RESPONSE TO SUBMISSIONS LETTER - TRAFFIC/VEHICLE MOVEMENTS

TPP REF: 16222

RE: Proposed Resource Recovery Facility, 20 Hearne Street Mortdale (SSD 7421)
Response to Submissions

Figure 1: Utilisation of Stacking Spaces – Typical Site Operation

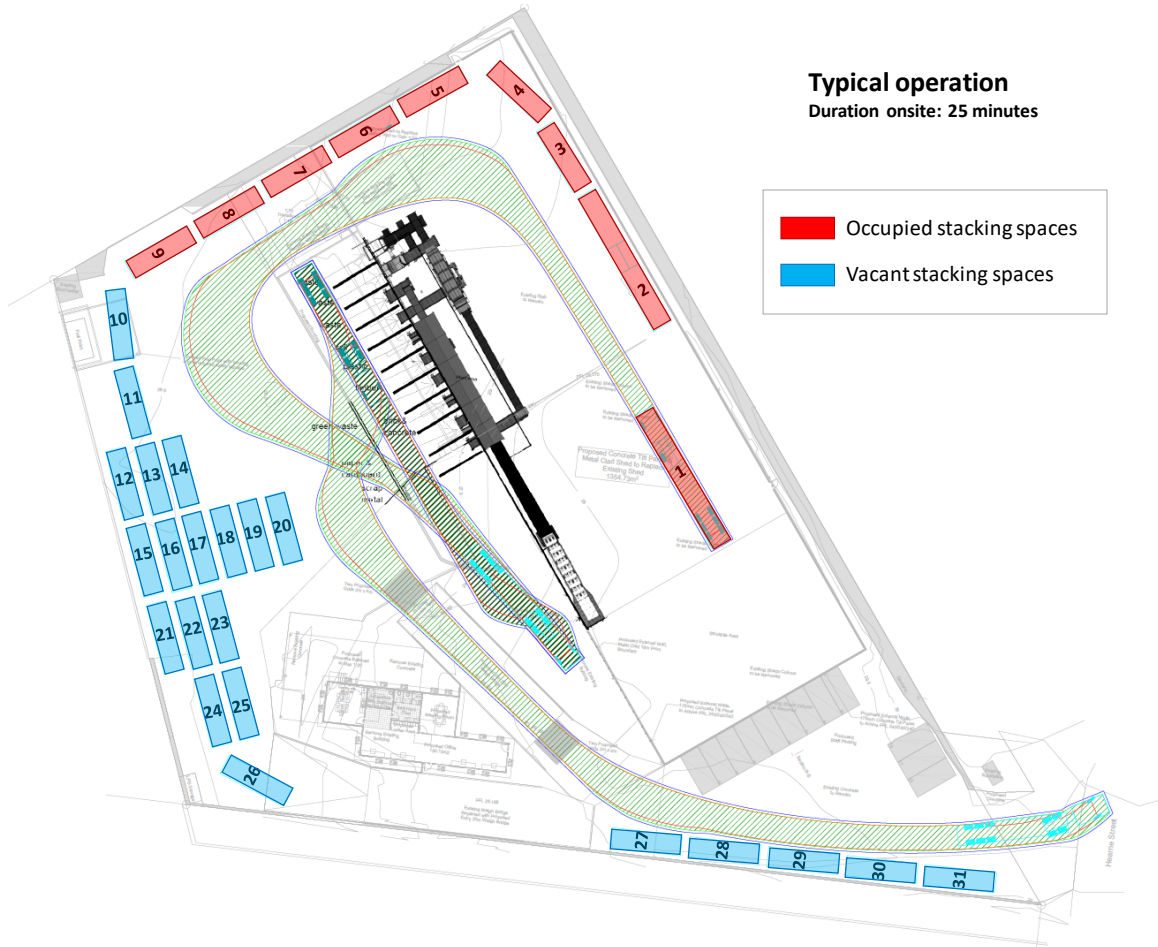
“the RTS has provided information regarding the capacity for ‘stacking’ on the site during the busiest peak hour, being 11am-12pm on weekdays. For a few hours before and after this time there is also considerable traffic, which could impact on stacking build up over the course of a day. The worst case scenario has not been taken into account, being a cumulative back up of trucks over time, especially due to unexpected circumstances. Since the limited size of the site is of particular concern to the Department, please provide additional evidence that the site can cope with the proposed traffic volumes in the above circumstances. Provide mitigation measures to be implemented in the event the site reaches stacking capacity.”

Based on a duration of 25 minutes onsite, each stacking space could accommodate 2.4 vehicles in one hour (60 minutes / 25 minutes). Therefore, during any hour of operation across the day, the proposed stacking arrangement could accommodate the turn-over of 74 vehicles (2.4 vehicles x 31 spaces).

The availability of stacking space within the site would be able to adequately store the 21 vehicles expected to arrive during the site's peak hour. Hence, queuing of heavy vehicles would be entirely accommodated and managed within the site and would not be expected to cause any impact on Hearne Street.

Therefore, the 21 vehicles expected to arrive during the site's peak hour could be easily accommodated across only nine stacking spaces. This means that queuing along the property driveway and on Hearne Street is not predicted. As a result, there would be 22 vacant stacking spaces remaining, as illustrated in Figure 1.
